ADDENDUM No. 02

Subject: Northeast High School – AC Upgrade Project
SDP Contract No. B-006c & 007c 2020/21

Location: Northeast High School
1601 Cottman Avenue
Philadelphia PA 19111

This ADDENDUM dated May 25, 2021 shall modify and become part of the Contract Documents for the work of this project. Any items not mentioned herein, or affected by, shall be performed strictly in accordance with the original documents.

DRAWING NO.
E101
SHEET 12 OF 18

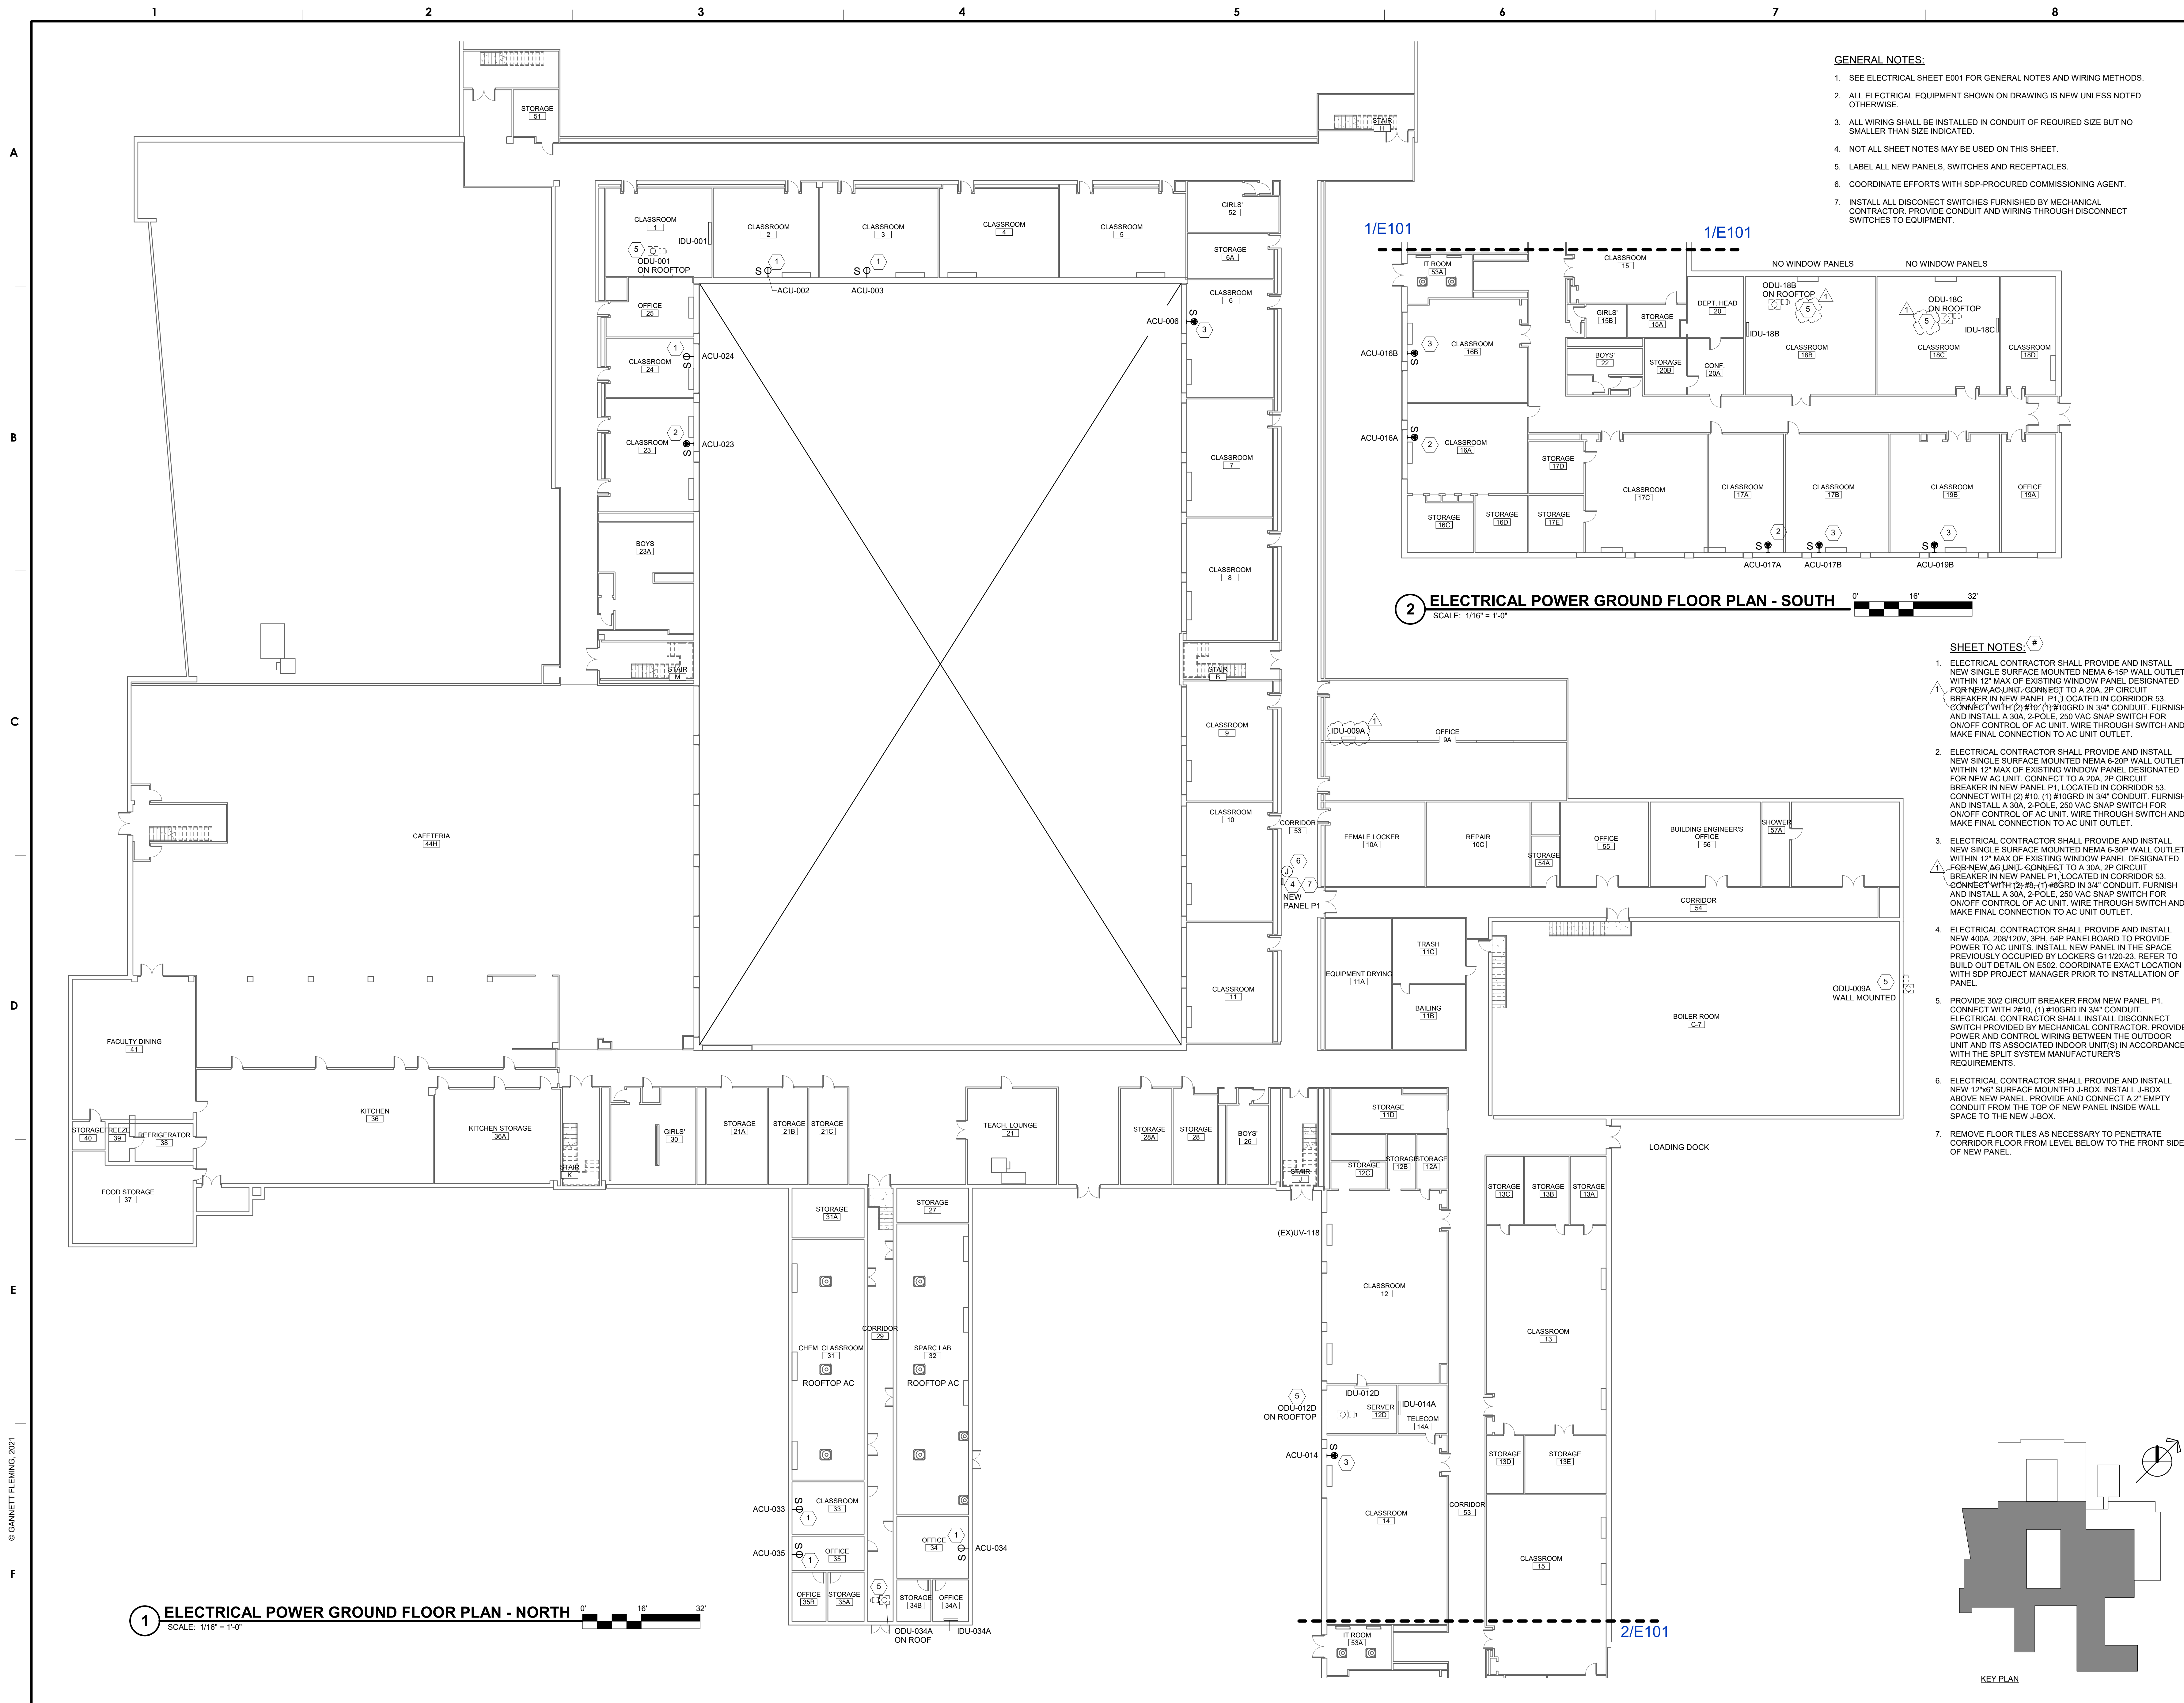
Drawing E101, sheet note #1 indicates to connect to a 20/2 CB in new panel P2. Is this the correct panelboard since the ground floor units are shown to connect to panel P1 on drawing E502? If P1 is the correct panelboard, ACU units 033 & 034 are shown with 30/2 CB's Which is correct?

Drawing E101, ACU 035 is shown but not indicated on M501. Is this unit being replaced? PTAC units 035 & 035B are shown on M502 but not on drawing E101 or E502. Are these units being installed?

Drawing E101, sheet notes 2 & 3 reference panel P2 when E502 indicates P1. Which is correct?

Drawing E101, ACU units 18B & 18C indicate sheet note 4. Is this correct or should it be sheet note 5?

Drawing E101, ODU-009A does not a note next to it? Is this being replaced?

Response: Note #1 on Drawing E101 will be revised to indicate “Panel P1” instead of Panel 2. For Units 033 & 034, the correct CB is 30/2. Panel schedule is correct.

Response: Drawings E101 & E502 will be updated to show units PTAC-035 & 035B as shown on M101.

Response: Panel P1 is the correct panel.

Response: Note #5 is correct.

Response: ODU-009A does have a note #5 next to it. Refer to E101 (Boiler RM C-7). The

designation inside room 9A should be "IDU-009A".

DRAWING NO.
E102
SHEET 13 OF 18

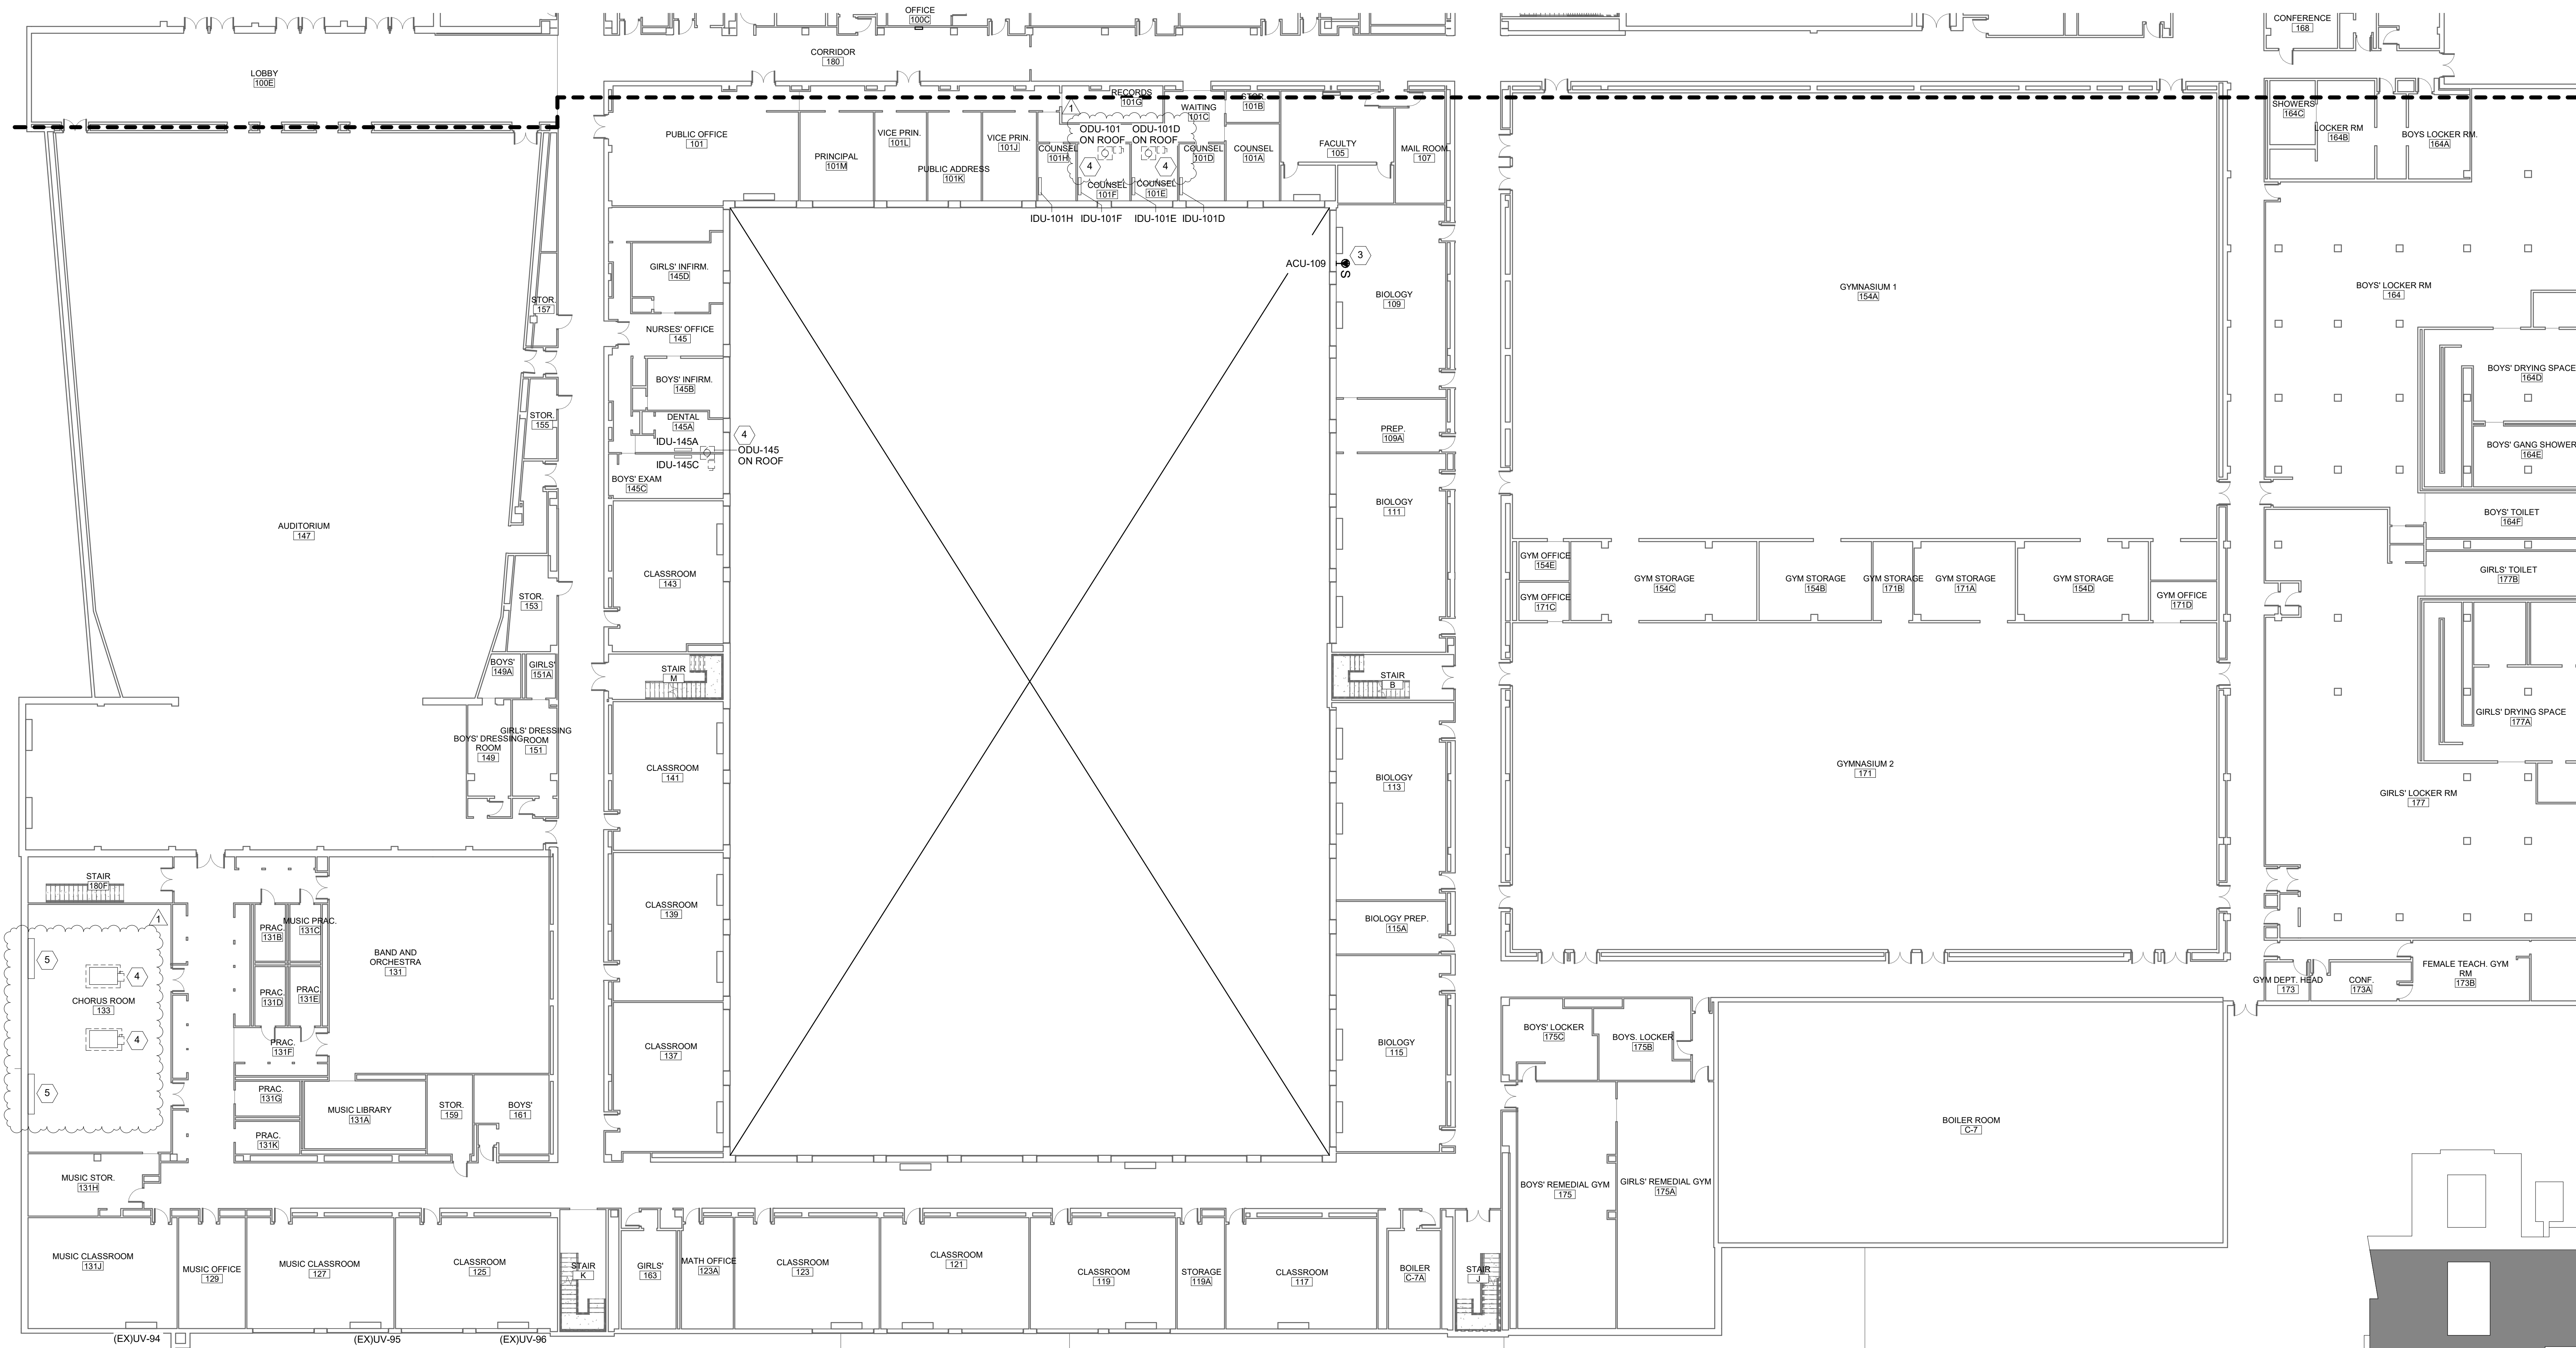
Drawing E102, sheet note #4 references panel P1. Is this correct or should it panel P2?

Drawing E102, are ODU-101E, ODU-101F and ODU-101H being provided? They are not shown on E102 or E502 but are shown in the schedule on M502 as IDU units.

Drawing E102, ODU 101D is not shown on this drawing or E502 but is shown on M502. Is this unit being provided?

Drawing E102, ODU 145A is not shown on this drawing or E502 and is only shown as an IDU on M502. Is this unit being provided?

Drawing E102, UV-133-1 & UV-133-2 are not shown on this drawing but are indicated on M502. Are they being installed?

Response: Panel P2 is the correct panel.

Response: Units referenced above will be provided and are shown on both E102 and M502.

Response: ODU-101D will be added to E102 and Panel P2 on E502.

Response: ODU-145 is shown on both E102 and M502. ODU-145 on roof will feed units IDU-145 A&C.

Response: Yes, these units will be installed and will be added to E102 and Panel P2 on E502.
